Economic Commission for Europe**Inland Transport Committee****World Forum for Harmonization of Vehicle Regulations****Working Party on Brakes and Running Gear****Eighty-second session**

Regulation No. 55**Proposal for amendments to Regulation No. 55 (Mechanical couplings)****Submitted by the Chair of the informal working group on Regulation No. 55***

Figure 1
Dimensions of the centre axle trailer

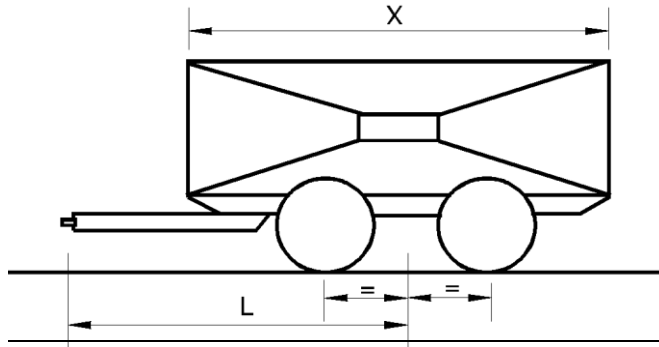
~~X — is the length of the loading area of the trailer, in metres (see Figure 1)~~

~~L — is the distance from the centre of the drawbar eye to the centre of the axle assembly, in metres (see Figure 1)~~

~~Note: $\frac{X^2}{L^2} \geq 1.0$ (If less than 1.0, the value of 1.0 shall be used)~~

The V value is a characteristic performance value of the amplitude of the vertical force imposed on the coupling by a center axle trailer. This performance value shall be verified as described in Annex 6 of this Regulation."

Figure 27
Dimensions of the center axle trailer

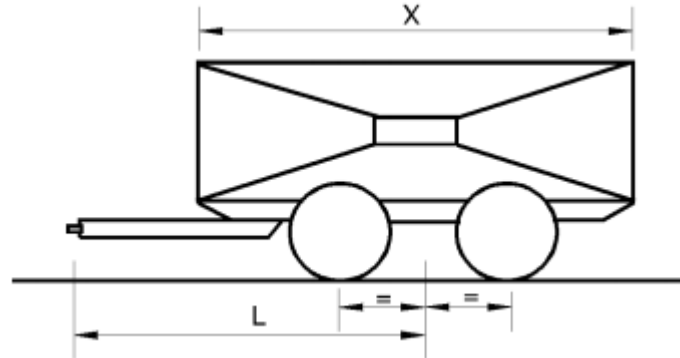
X is the length of the loading area of the trailer, in meters (see Figure 27)

L is the distance from the center of the drawbar eye to the center of the axle assembly, in meters (see Figure 27)

Note: $\frac{x^2}{L^2} \geq 1.0$ (If less than 1.0, the value of 1.0 shall be used)
